Application No.: 09/750,465

Docket No.: JCLA6707

In The Drawings:

FIG. 1

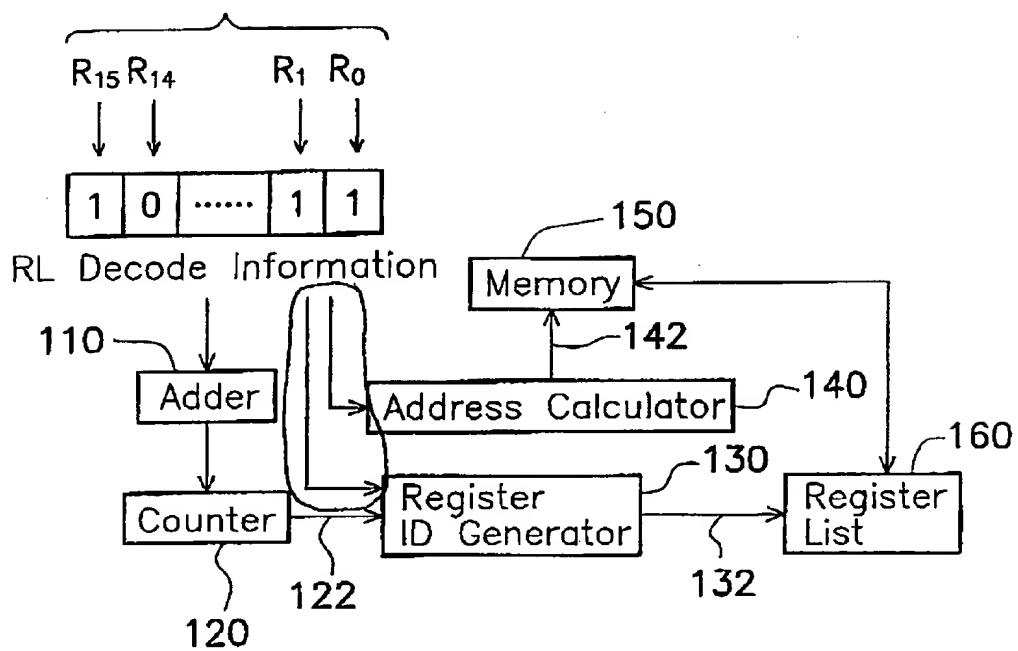
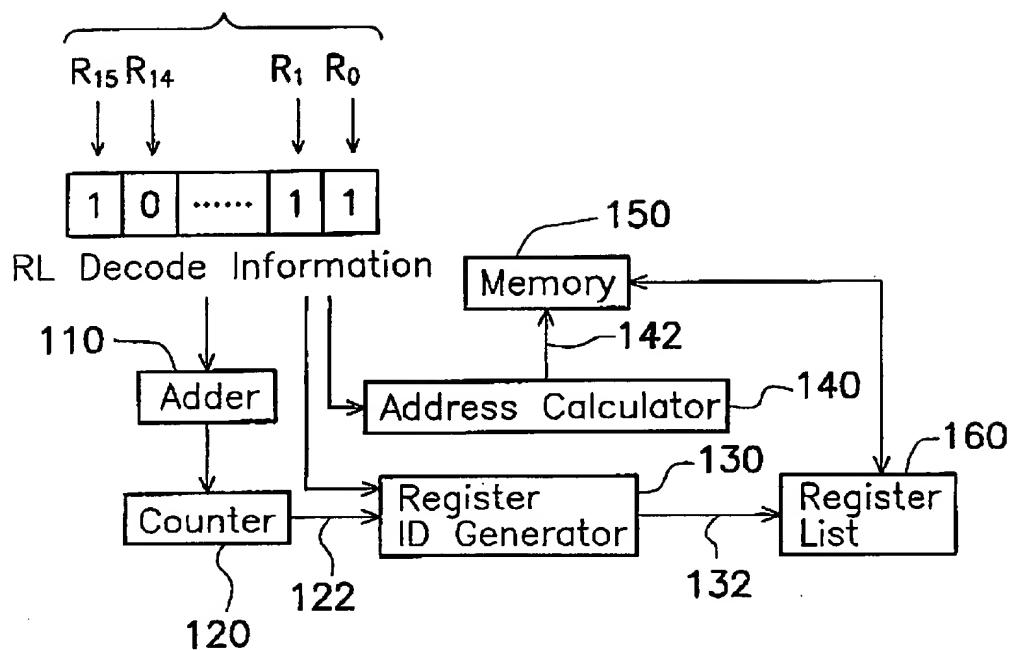
Please change the amended Fig. 1 for the original Fig. 1. The applicants amended Fig. 1 according to the Examiner's suggestion, i.e., two communication paths are added to show that the RL decode information is sent to the register ID generator and the address calculator, and no new matter is added.
